78-10-03 PIPER: Amendment 39-3212. Applies to all J-3, J-4, J-5, PA-11, PA-12, PA-14, PA-16, PA-18, PA-20 and PA-22 type aircraft.

In order to prevent inadequate fuel venting, accomplish the following:

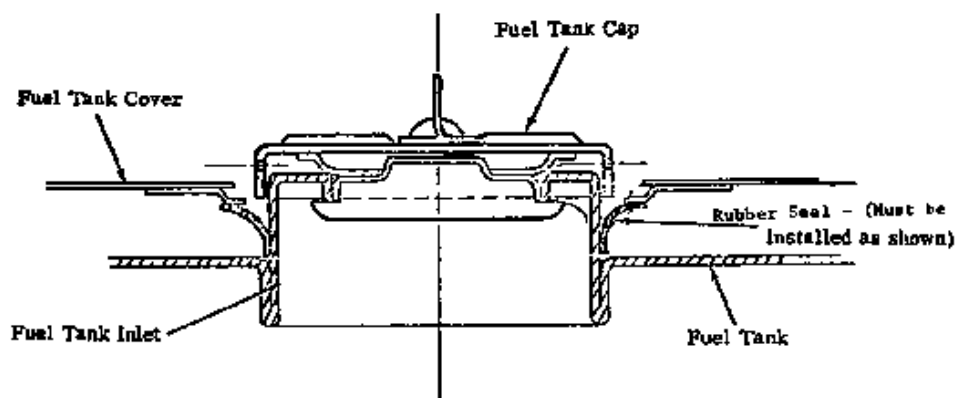
(b) Drill 2 additional vent holes .098 inch diameter through locking cam of fuel cap (Sketch 2) in accordance with instructions of Piper Service Bulletin No. 573 dated February 8, 1978, or approved equivalent.

(c) Upon compliance with (b), vibro-etch Part No. 60707-04 as shown in Sketch 2.

SKETCH 1
78-10-03

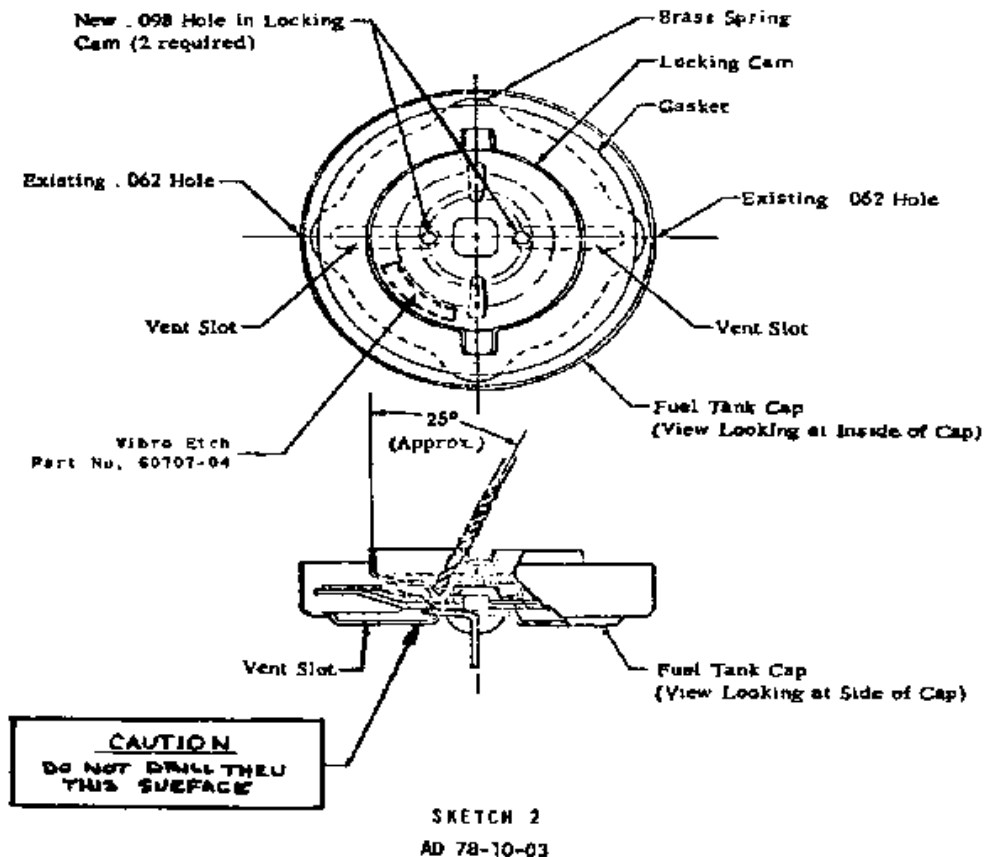
(a) Modify fuel caps and inspect fuel tank inlet rubber seal in accordance with Piper Service Bulletin No. 522 dated September 28, 1976, (former AD 77-09-09 Sketch 1) or approved equivalent. AD 78-10-03
